Amendments to the Drawings:

REMARKS

Fig. 2

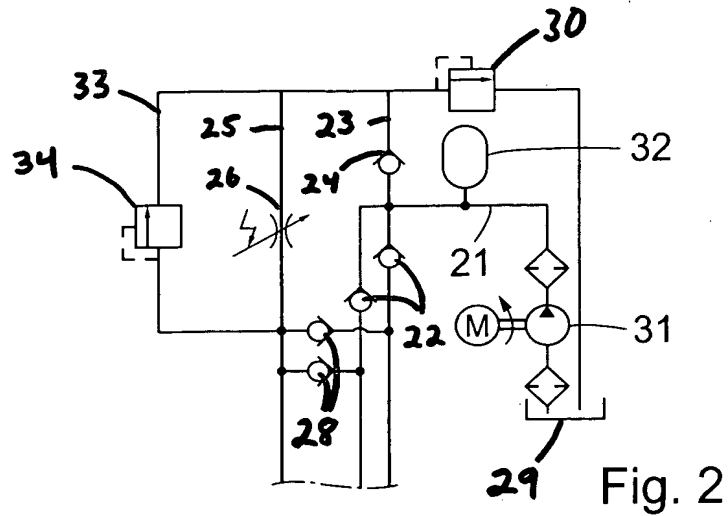
Figures 2-4 and 6-10 have been objected to as not containing reference characters for all elements shown therein. Figures 2-4 and 6-10 have been amended so as to show reference characters for all elements. Applicant submits that no new matter has been added, as all added reference characters were present in the specification as originally filed and were shown in Figure 1 and/or Figure 5 as originally filed.

The attached sheets of drawings include changes to Figures 2-4 and 6-10. These sheets, which includes Figures 2-10, replace the original sheets including Figures 2-10. In Figures 2-4 and 6-10, previously omitted reference characters are added.
